RESIDENTS AGAINST THE CF3 INCINERATOR
A RESPONSE TO
THE MOR HAFREN LANDSCAPE and VISUAL IMPACT ASSESSMENT

This document is a response to the applicant's Landscape and Visual Impact Assessment document, which supports their planning application (DNS/3236340) for an incinerator at Newlands Road, Cardiff.

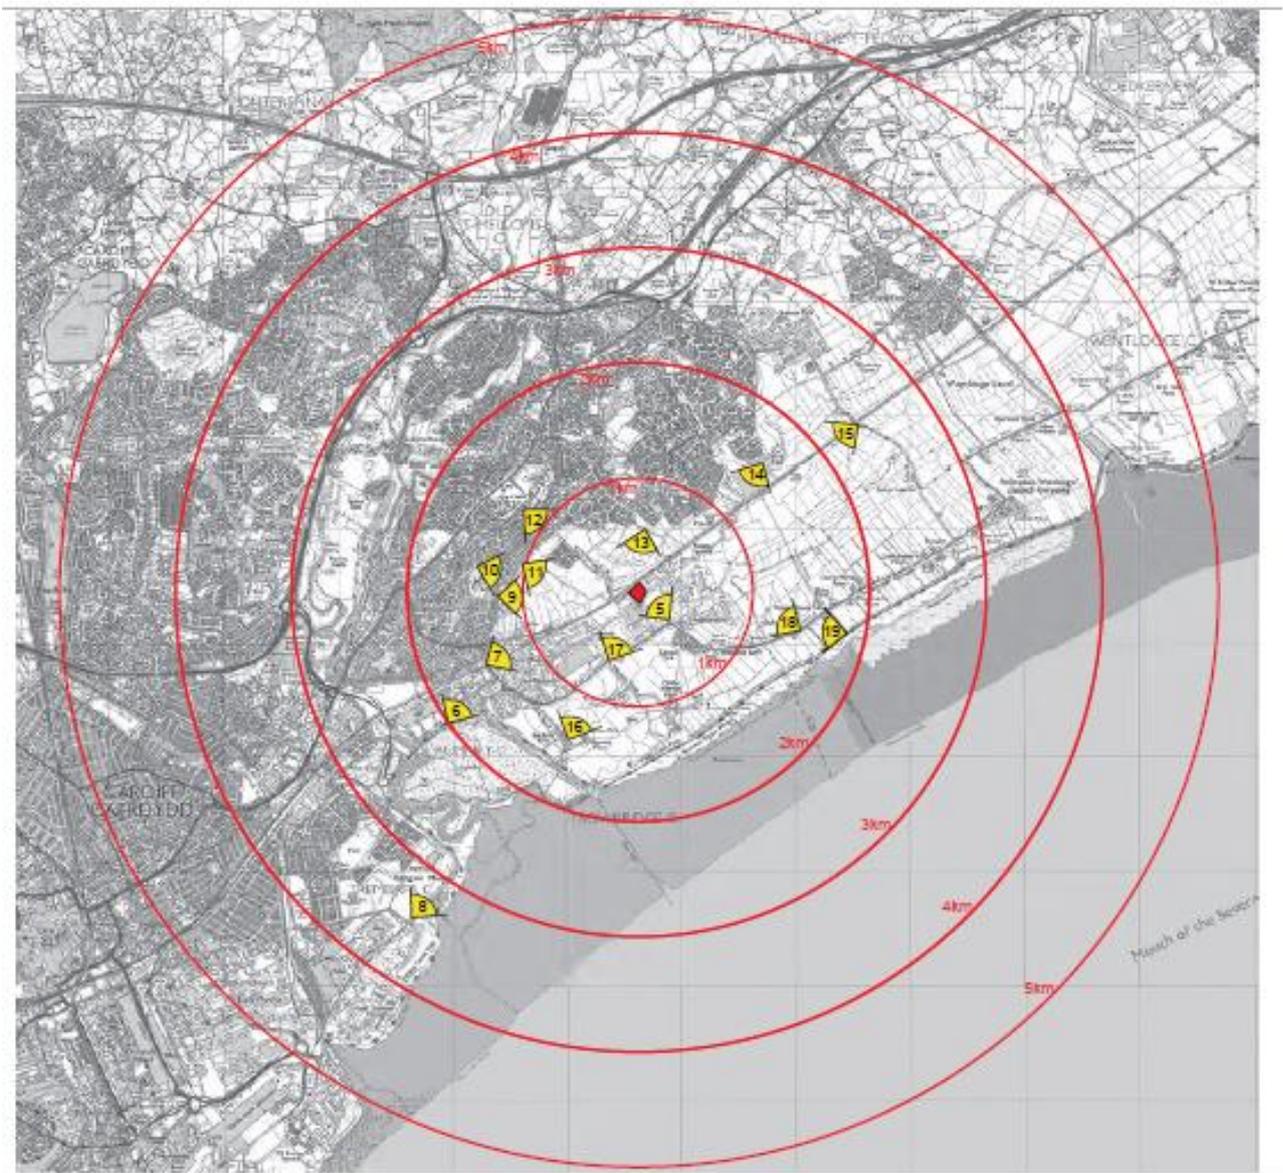
We note that the furthest viewpoint taken into consideration is 3.2Km from the site on Rover Way and there are no viewpoints taken from the points stated above.

We also observe and comment that although the study area is stated as comprising an area of 5km radius, all but 2 of the 19 viewpoints are within a 2km radius. This mismatch is not explained and calls into question the robustness of the applicant's assessment.

We assume viewpoints 1, 2, 3, and 4, between 20m and 130m from the site, are not shown as the scale of the graphic is too small.
